Entergy Nuclear Operations, Inc.
(Indian Point Nuclear Generating Units 2 and 3)

PRE-FILED SUPPLEMENTAL REPLY WRITTEN TESTIMONY OF

Dr. RICHARD T. LAHEY, JR.

REGARDING CONTENTION NYS-25

Figure 1: Comparison of Limit Line (LL) and Best Estimate (BE) predictions, with embrittlement (BE_e) and without embrittlement (BE_{ne}).

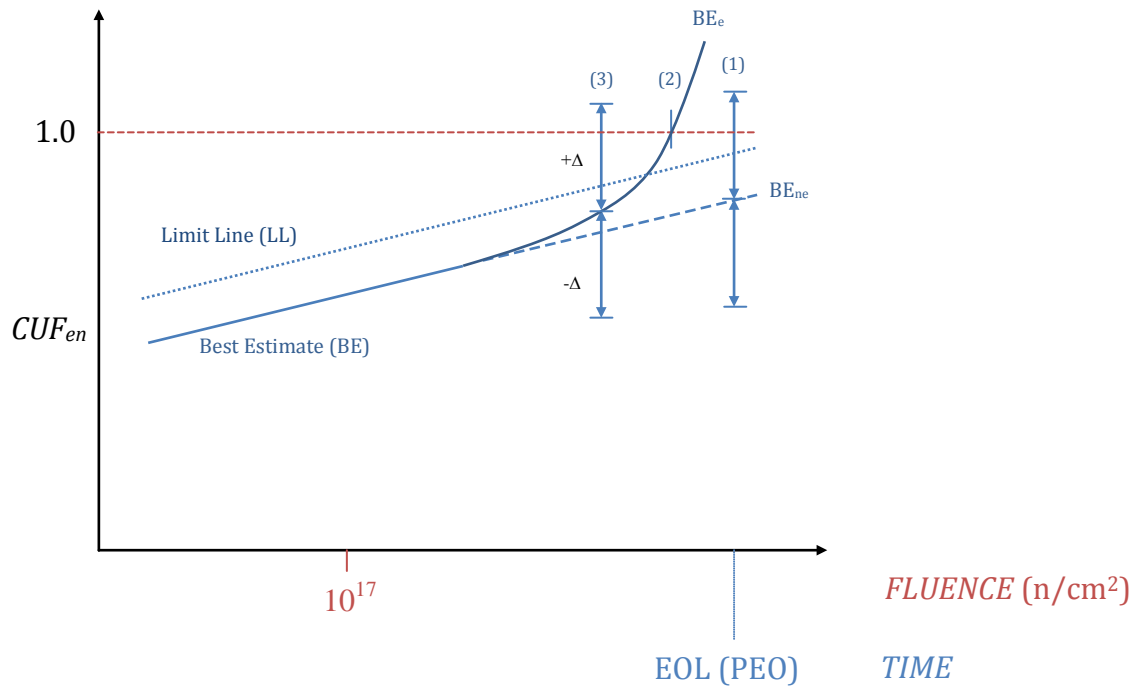
2 A. I prepared this Figure to visually illustrate some of

3 the concerns that I have set forth in my testimony in this

4 proceeding. Specifically, this Figure shows three important

5 things: (1) a typical WESTEMS™ "Limit Line" prediction, (2) a

6 "Best Estimate" prediction of CUF_{en}, the cumulative usage factor

1 uncertainty interval (Δ), and, (3) how the neutron fluence-
2 induced embrittlement of a RVI structure, component, or fitting
3 can dramatically increase the possibility of a fatigue failure,
4 as represented by the cumulative usage factor under PWR
5 operating conditions, CUF_{en} , being equal to unity. This figure
6 applies to RVI structures, components, and fittings made of
7 stainless steel or other materials. In summary, in Figure-1, I
8 have illustrated two different approaches for calculating a
9 time-dependent CUF_{en} , namely the "Limit Line" and the "Best
10 Estimate" calculation. For the "Best Estimate" line, I also
11 illustrate typical uncertainty intervals, delta (Δ), and the
12 effects of fatigue on embrittled (e) and on non-embrittled (ne)
13 RVIs.

17 [REDACTED]
18 [REDACTED] The "Limit Line" shown in Figure-1 includes
19 Entergy's implicit assumption that a stainless steel RVI
20 structure, component, or fitting remains perfectly ductile, and
21 thus shows that the CUF_{en} for a RVI will increase with an
22 increasing number of fatigue cycles, but that it is not affected
23 by the fluence. The "Limit Line", therefore, uniformly

1 increases in CUF_{en} even after the fluence exceeds 10^{17} n/cm²,
2 where significant embrittlement begins to develop (i.e., it is
3 assumed that the number of cycles to failure are not a function
4 of fluence). Figure-1 shows that, as the RVI component
5 approaches the end of life (EOL) for the period of extended
6 operation (PEO), [REDACTED] "Limit Line" will approach
7 (but still be below) $CUF_{en} = 1.0$. This is depicted as location
8 (1).

11 A. Not necessarily. As shown in Figure-1, a "Best
12 Estimate" prediction plus the uncertainty (Δ) may predict
13 possible RVI structure, components or fitting failures (i.e.,
14 $CUF_{en} = 1.0$), sooner than the "Limit Line" would. Moreover, the
15 effect of embrittlement can make the situation much worse. The
16 problem is that no one knows how much conservatism, if any, is
17 in the [REDACTED] "Limit Line". As a consequence, we can have no
18 confidence that "Limit Line" results near $CUF_{en} = 1.0$, are
19 sufficiently conservative to bound all the possible
20 uncertainties, as illustrated in Figure-1 by Δ .

20 A. Location (1) shows that, even if embrittlement is not
21 considered, RVI fatigue failure may occur by the end of life for
22 the period of extended operation. This is because the sum of a

1 "Best Estimate" prediction plus the uncertainty interval (Δ)
2 associated with this prediction would exceed $CUF_{en} = 1.0$. In this
3 case the "Limit Line" result is clearly non-conservative.

6 A. Location (2) shows that embrittlement can result in
7 the physical failure of the RVI well before the end of life for
8 the period of extended operation.

11 A. At location (3), the "Best Estimate" plus uncertainty
12 (Δ) for the case considering embrittlement (BE_e) predicts
13 possible failure of the hypothetical RVI component well before
14 the end of life for the period of extended operation, even
15 though the "Limit Line" prediction indicates substantial margin
16 to failure at this point. That is, at location (3) the CUF_{en} for
17 the "Best Estimate" line, accounting for embrittlement and for
18 all uncertainties (i.e., $BE_e + \Delta$), exceeds unity. Moreover, as I
19 have stated in my previous testimony, highly embrittled RVIs may
20 fail even sooner than by fatigue alone if significant seismic or
21 shock loads occur. That is, fatigue-weakened and embrittled
22 structures cannot tolerate large impulsive seismic and shock
23 loads like fully ductile structures can. Moreover, other

1 synergistic aging effects, such as the thermal embrittlement (TE)
2 of some CASS RVIs (the upper part of the core support columns)
3 would may move the BE_e curve to the left of its position shown in
4 Figure-1 (i.e., the RVI would be predicted to reach failure,
5 $CUF_{en} = 1.0$, even sooner than the cases (2) and (3) in Figure-1).

8 A. Yes. Because of Entergy's failure to explicitly
9 account for uncertainties, and for the effect of embrittlement
10 on fatigued RVIs, we can have no confidence in the "Limit Line"
11 type of CUF_{en} predictions [REDACTED]
